SUBJECT: INITIAL EXAMINATION REPORT NO. 50-123/OL-03-01, UNIVERSITY OF
MISSOURI–ROLLA

Enclosures: 1. Initial Examination Report No. 50-123/OL-03-01
2. Facility comments with NRC resolution
3. Examination and answer key (RO/SRO)

We are presenting our review of the written operator licensing examination given at the University of Missouri - Rolla Nuclear Reactor Facility during the evening of March 10, 2003. We have reviewed the test and received comments from trainees after they completed the test that we wish to respond to. The following questions have answers that we would like you to address.

Using the drawing of the purification system provided, identify the components (a through h) with the correct name from Column B. (Note only one answer per item, not all choices in column B are used.)

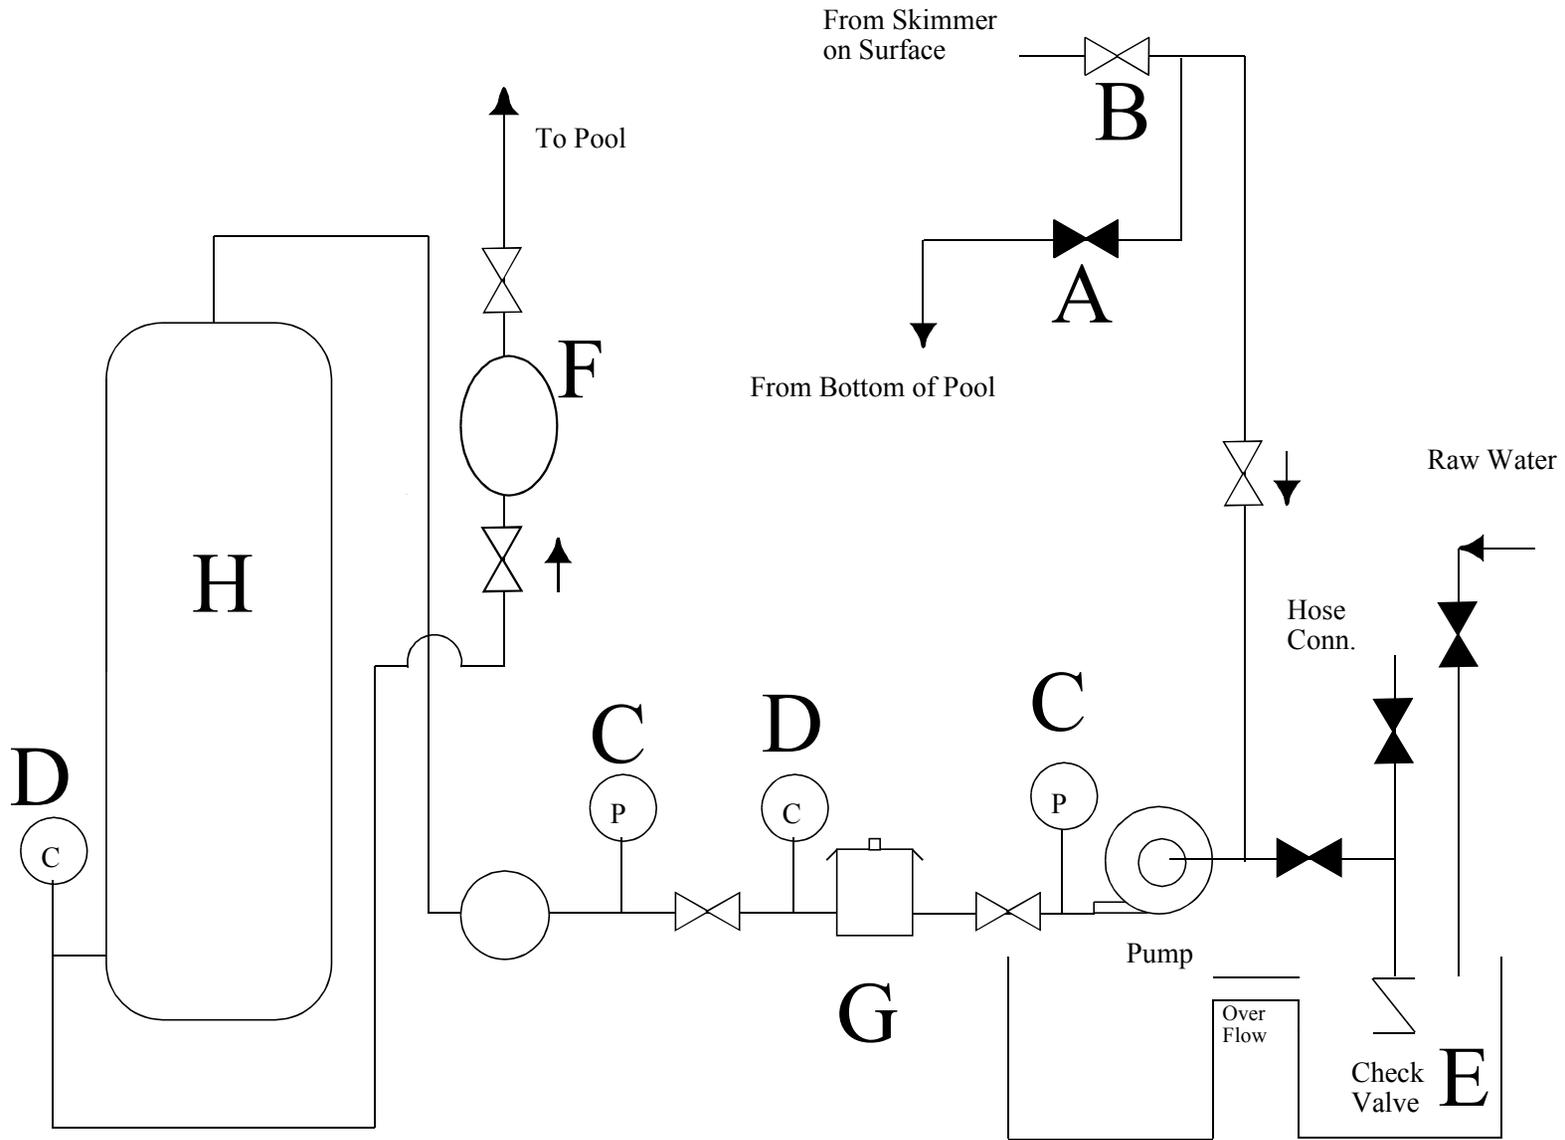
C.1 A typo in the answer sheet for F list "10" it should be "5".

- C.1 Agree with facility comment as written. Answer key changed to recognize “5” as correct answer.
- C.11 Agree with facility comment as written. Question deleted.

C.1a, 6; b, 7; c, 4; d, 3; e, 8; f, 40 **5 answer changed per facility comment;** g, 2; h, 1
REF: SAR § 5.2, pp. 5-1 – 5-3, also Figure 22, p. 5-4.
